Entergy  
Operations

W3F192-0020  
A4.05  
QA

Subject: Waterford 3 SES  
Docket No. 50-382  
License No. NPF-38  
Technical Specification Change Request NPF-38-123

DESCRIPTION AND SAFETY ANALYSIS  
OF PROPOSED CHANGE NPP-38-123

Figure 1

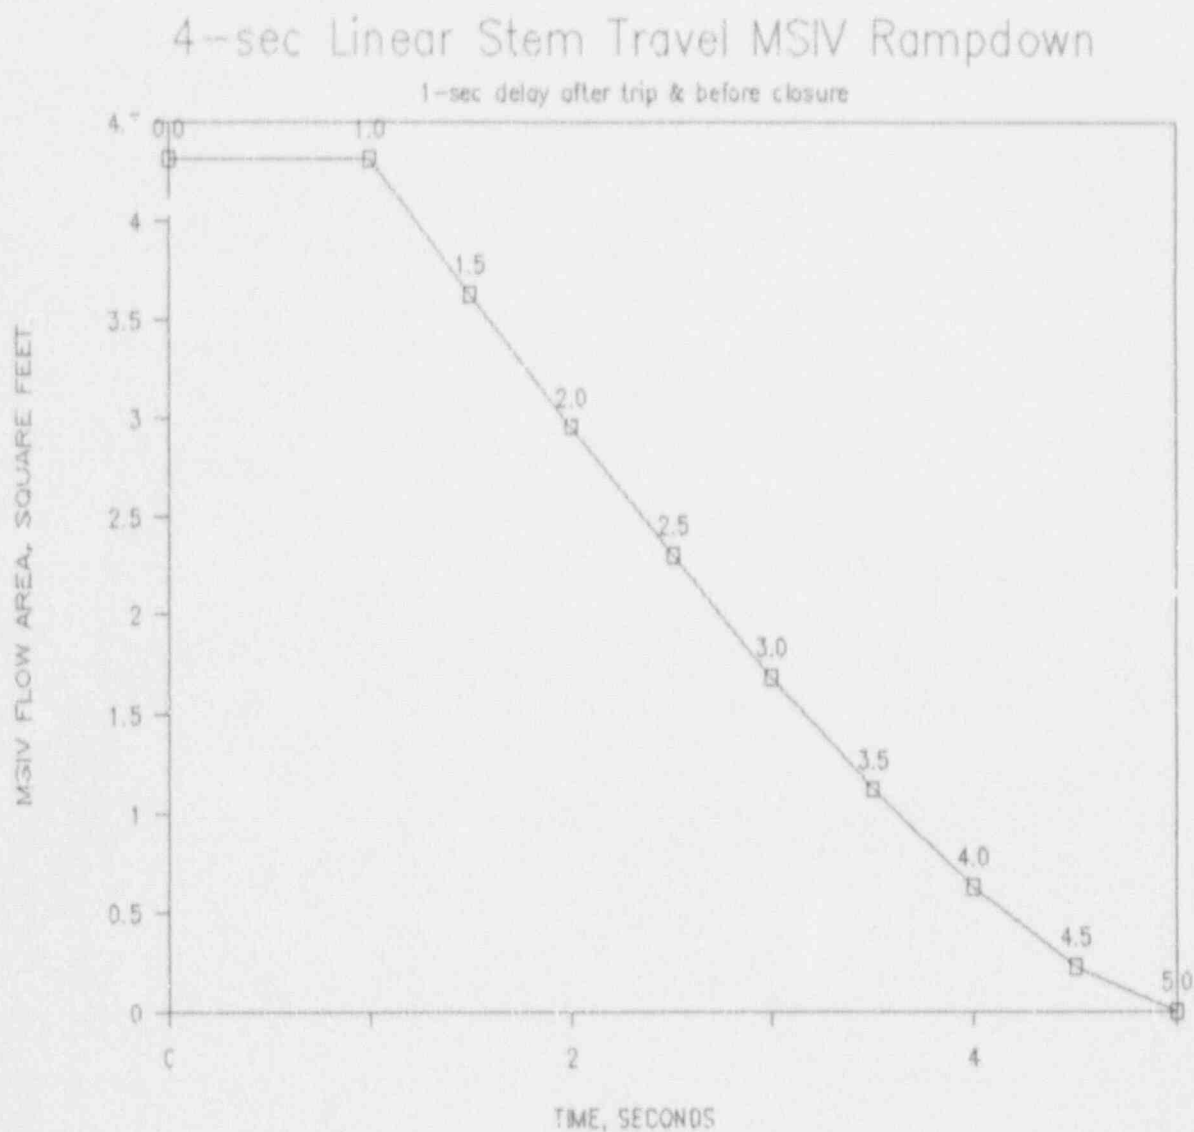
MSIV closure time. These analyses use a more detailed representation of the steam line piping and pressure drop from SG to MSIV. In addition, more realistic MSIV closure characteristics were used. Instead of an instantaneous closure, the MSIV flow area was decreased as shown in Figure 1.

Illustration of the MSIV Linear Stem Stroke Rate Closure
